Hornsby Shire Council

Hornsby Quarry Rehabilitation works including bulk earthworks (and associated civil works including construction of access tracks, drainage and retaining walls), site remediation, tree removal, revegetation work and site rehabilitation

Response to Submissions and Revised Project Scope

VOLUME 1 – MAIN REPORT

Figure 7.4

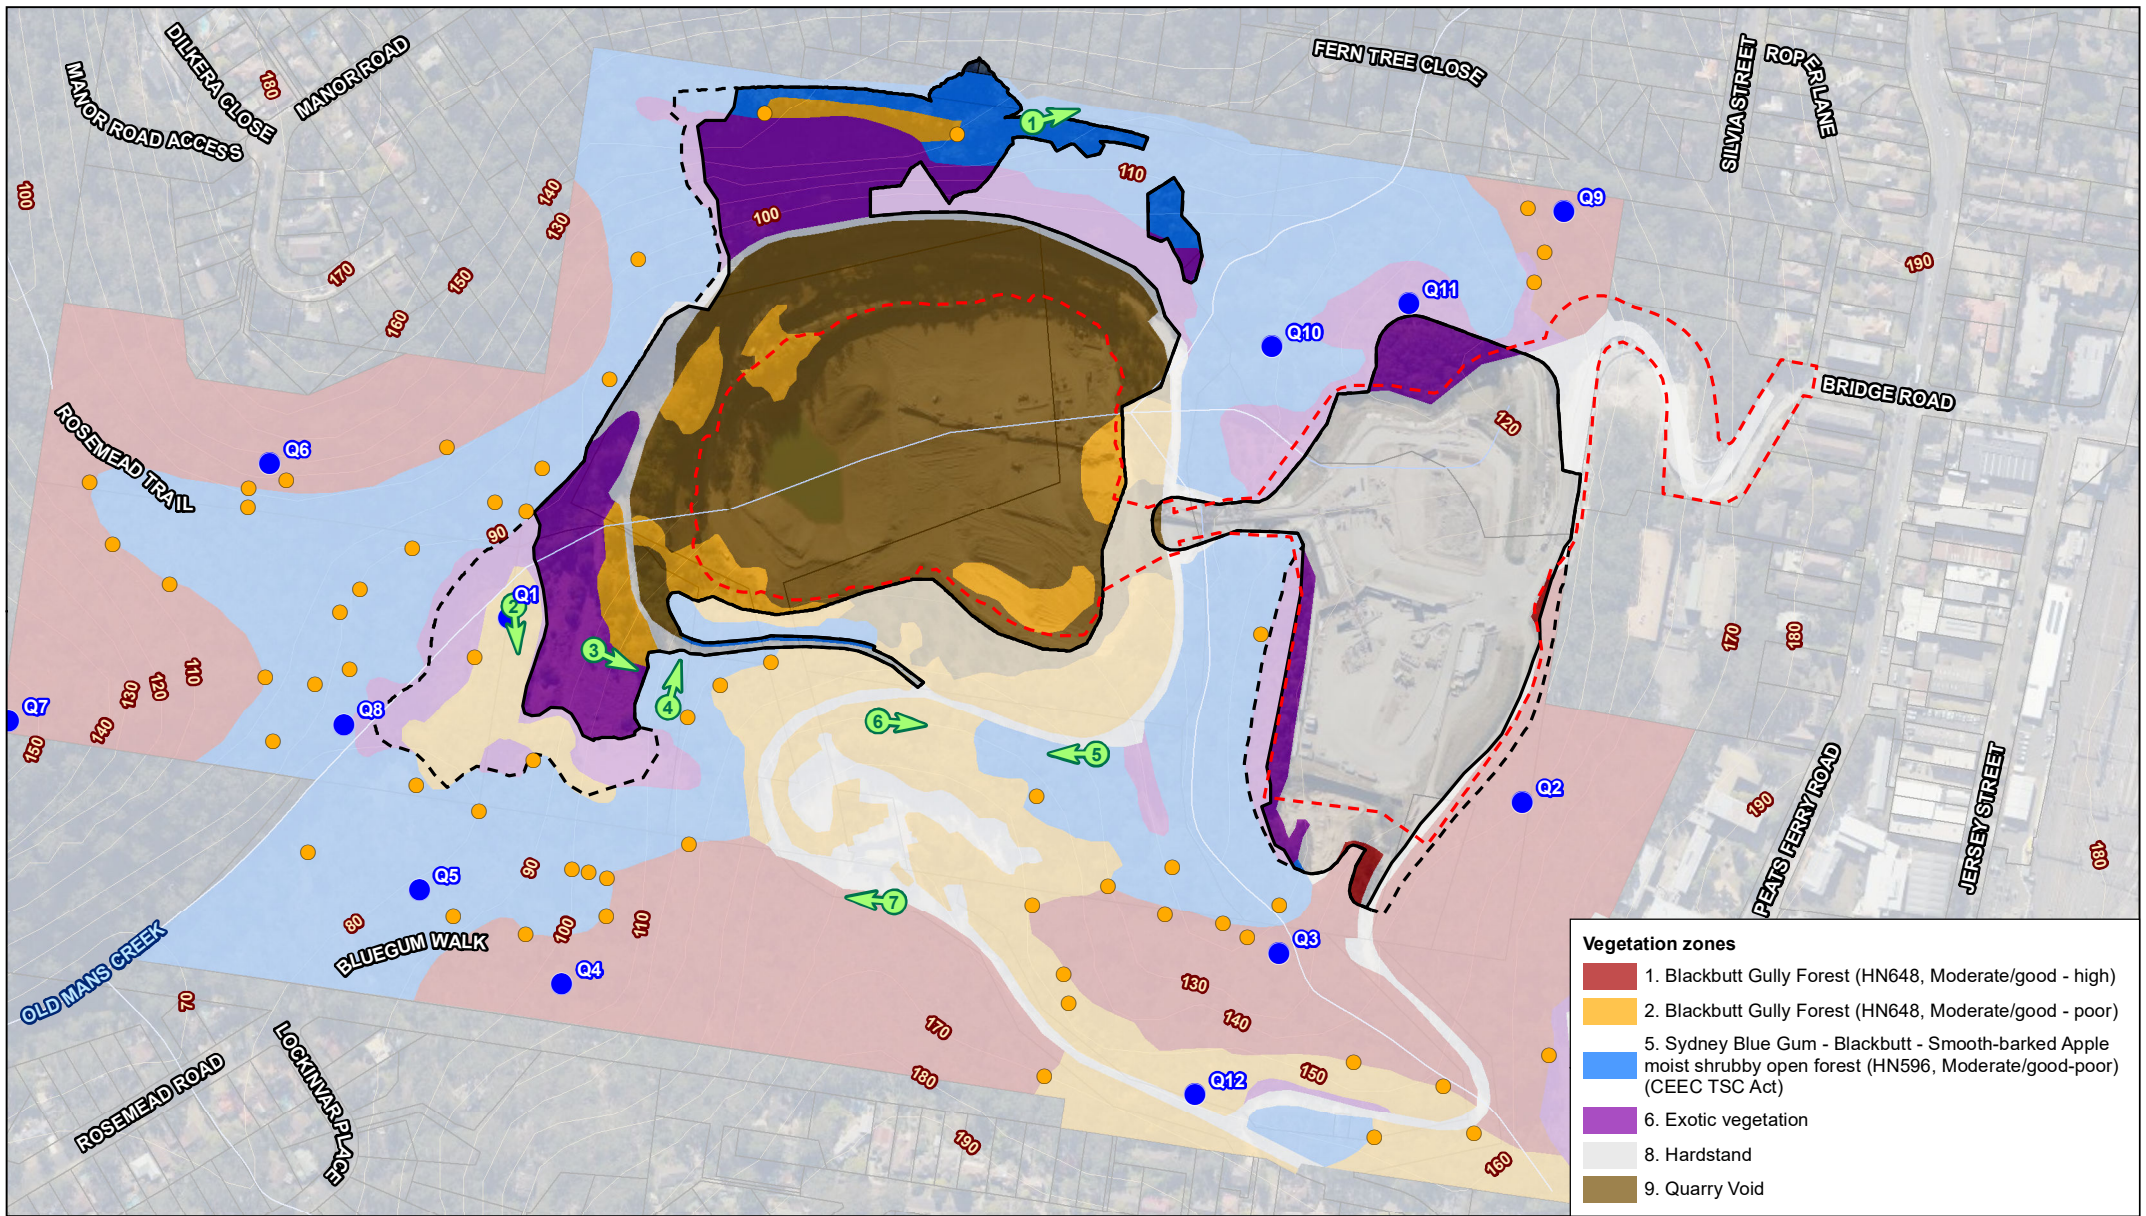
Vegetation to be impacted by the new layout is shown on Figure 7.4.
